TOWN COUNCIL WORKSHOP

**January 6, 2026
6:00 PM**

SUBJECT: Town Square by Library Restroom Facility – Review of Two Concept Options

Option 1

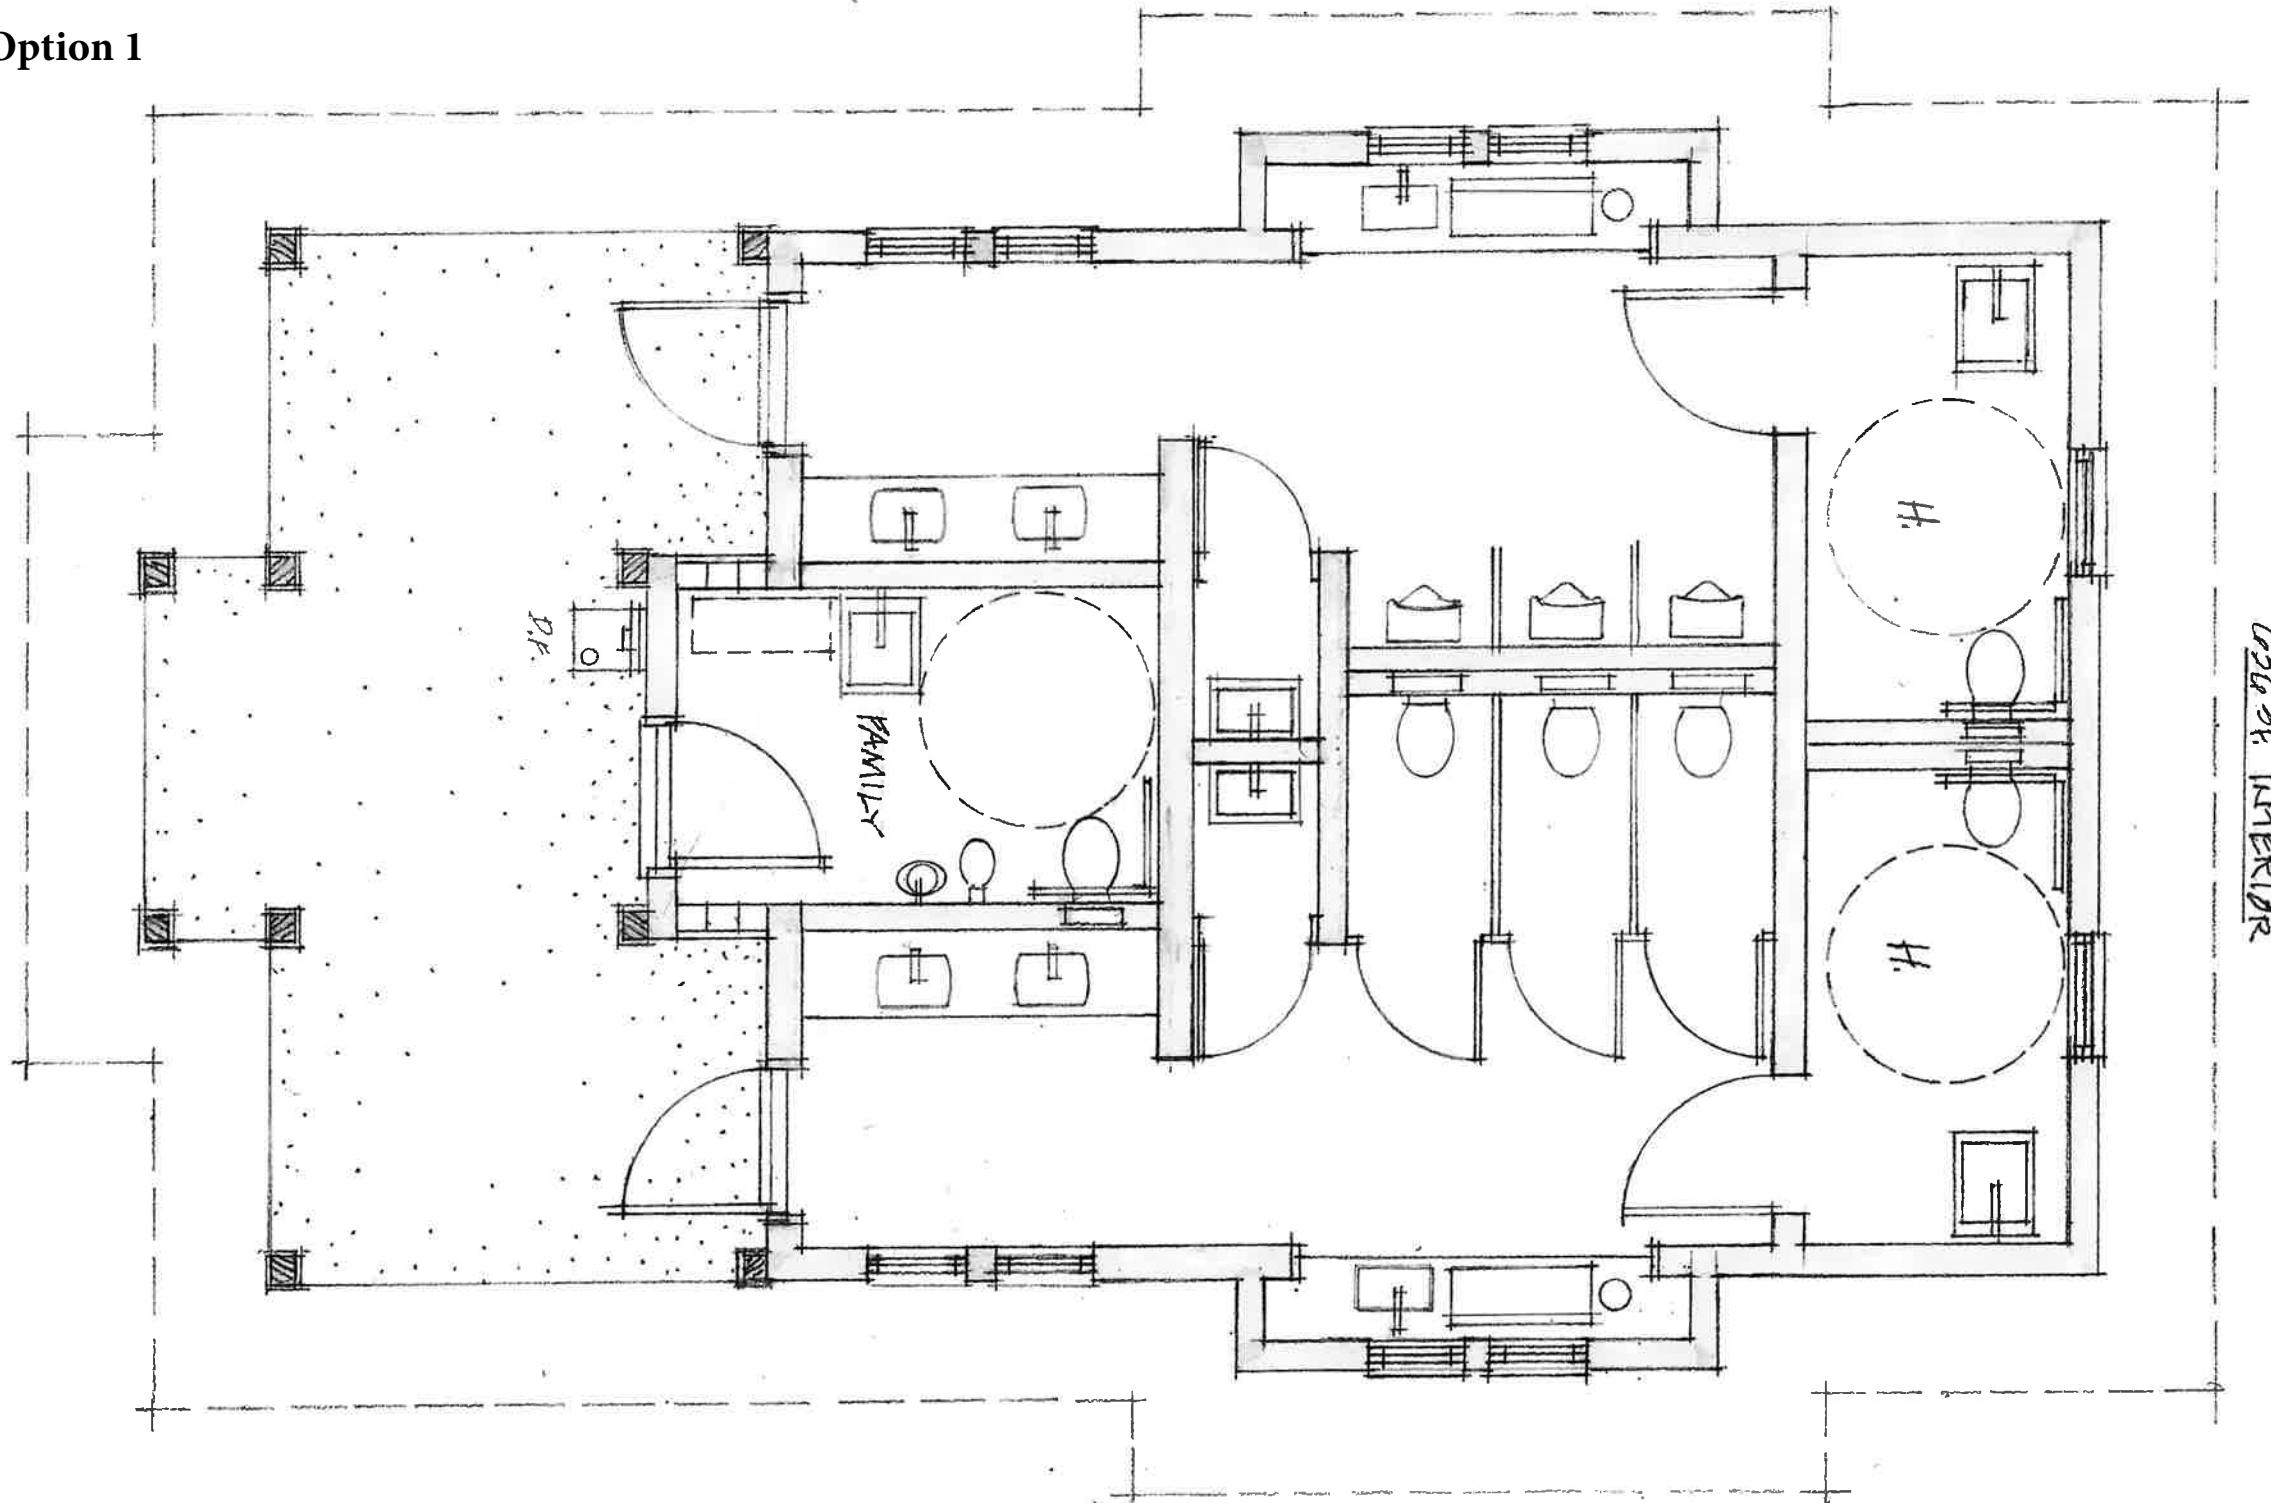
Option 1 – Town Council Concept:

Reflects feedback from the November 11 Town Council meeting, including:

- Removal of toddler fixtures in ADA stalls (retained only in the family restroom)
- Relocation of sinks to the front foyer and addition of two stalls to the women's side
- Removal of dual side "wings" in favor of a single storage area or internal janitor's closet
- Addition of a water bottle refill station under the covered porch
- Straightened center wall between men's and women's sides
- Reduction to one baby changing station per restroom and one in the family restroom (three total)
- Inclusion of touchless fixtures, ADA-accessible push-button entry, air conditioning, and full-height masonry walls

Option 2

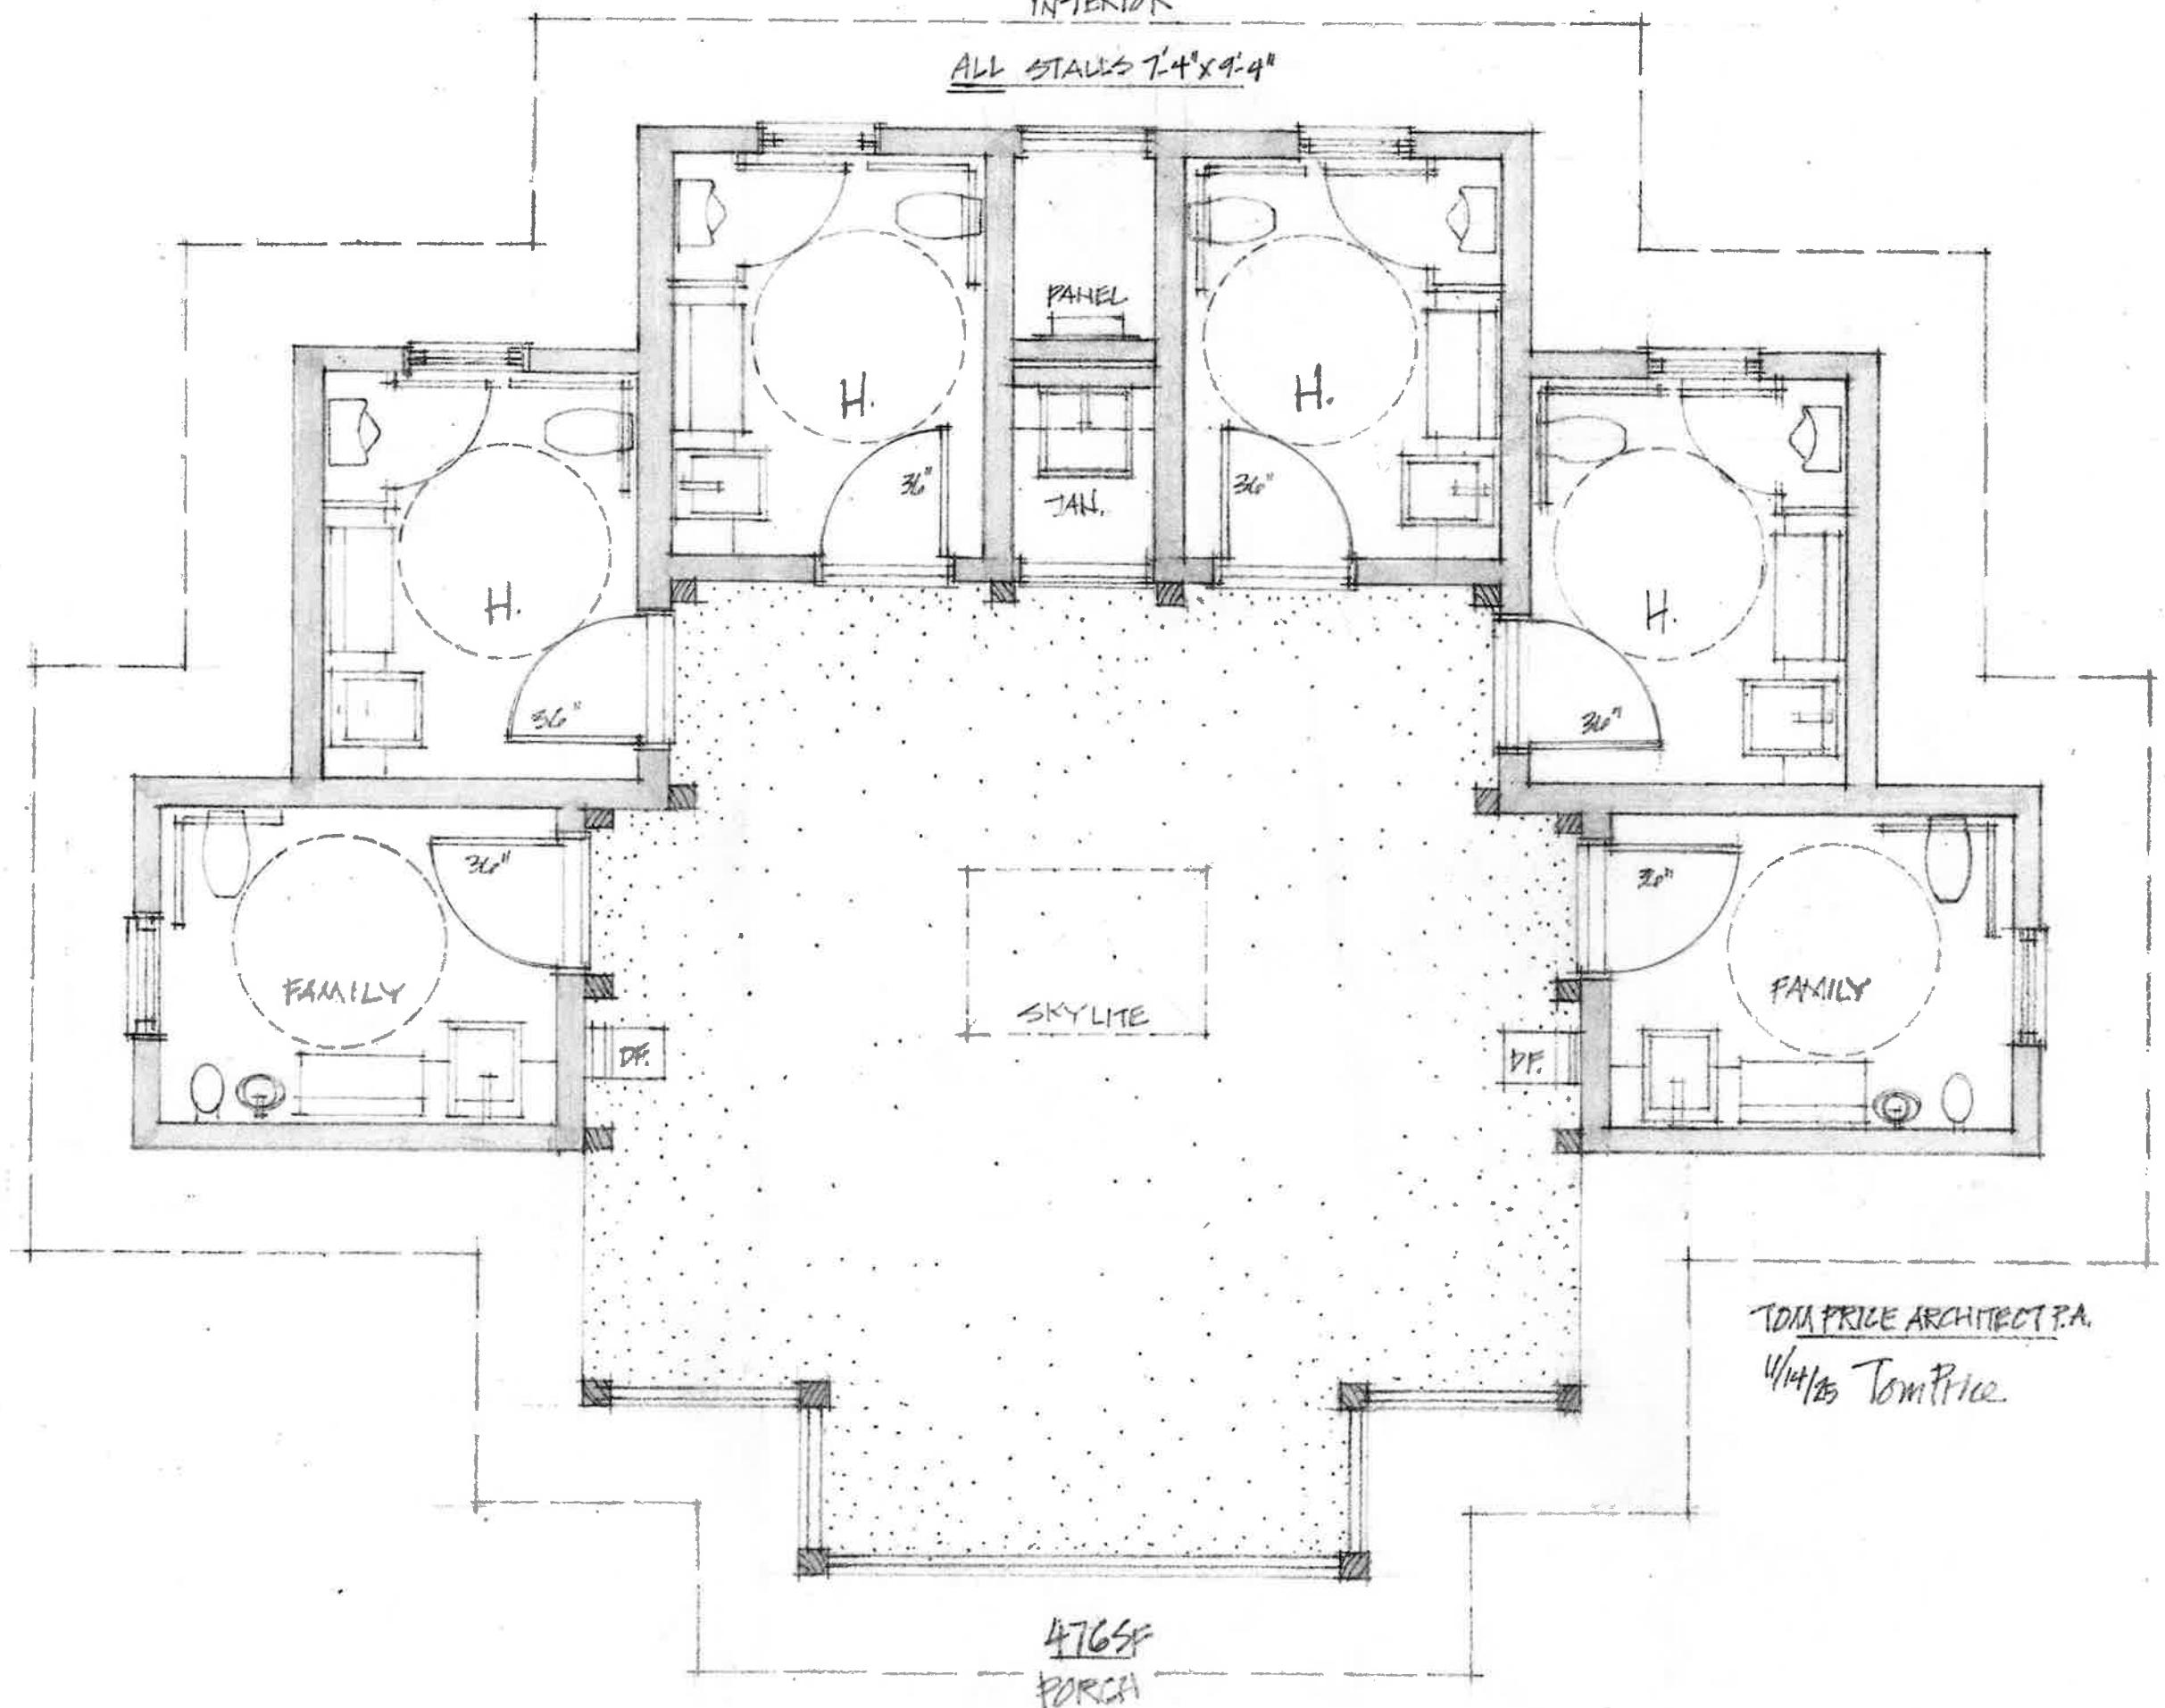
Option 2 – Resident Input Concept:

Suggests a modular-style approach with three to four single-user accessible units, each with an individual entrance from the outside.

- Units could be gender-specific or unisex
- Each includes its own baby-changing station
- Modular layout provides operational flexibility if one unit is out of service
- Porch optional; weather-protected doors recommended
